Change Order

Hardin County Early College & Career
Center
University Drive
Elizabethtown, Kentucky

CHANGE ORDER NUMBER: 006**DATE:** June 30, 2014**TO CONTRACTOR (Name and address):**

Work Changes Proposal Request

P1.1A PARTIAL LOWER LEVEL PLAN - AREA 'A' - PLUMBING - WATER & GAS

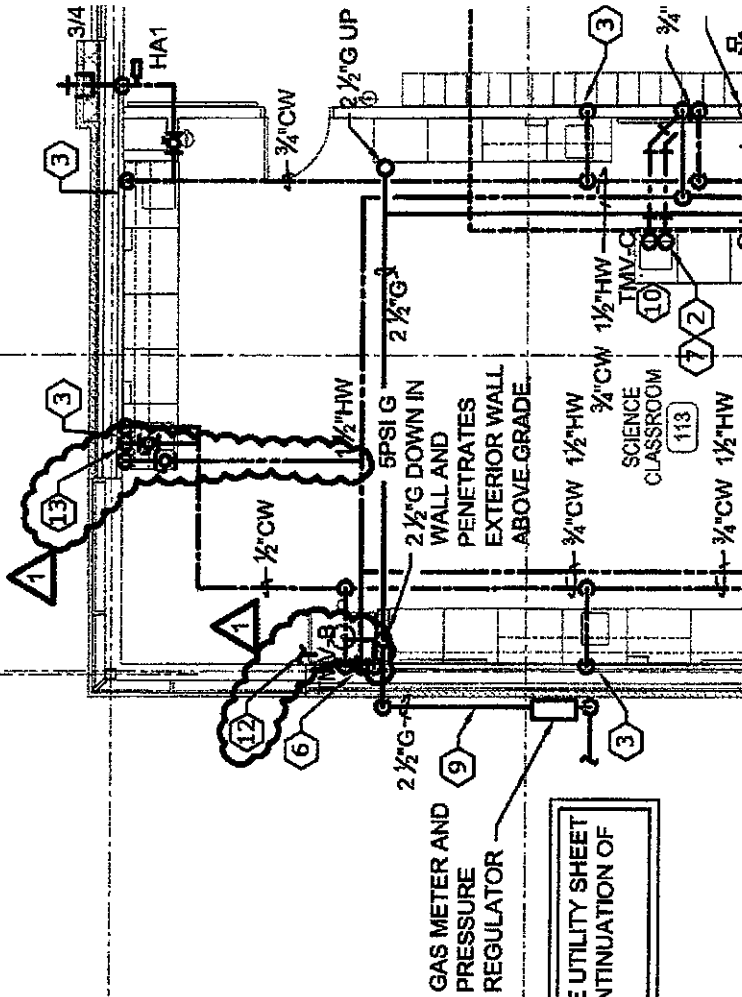
Provide pricing for new water lines to Owner-furnished ice machine and whirlpool, per the attached drawing.

12. 3/8" SOFT INSULATED COPPER TO OWNER PROVIDED ICE MAKER MACHINE. INSULATE PIPE. INSTALL BALL VALVE AT CONNECTION POINT. INSTALL EXPOSED IN CORNER.
13. 1/2" HOT AND COLD TO OWNER PROVIDED MIXING VALVE FOR WHIRLPOOL FILLER. INSTALL EXPOSED ON WALL. INSULATE SUPPLIES. COORDINATE LOCATION WITH ARCHITECT/OWNER. INSTALL SHUTOFF VALVES ABOVE CEILING.
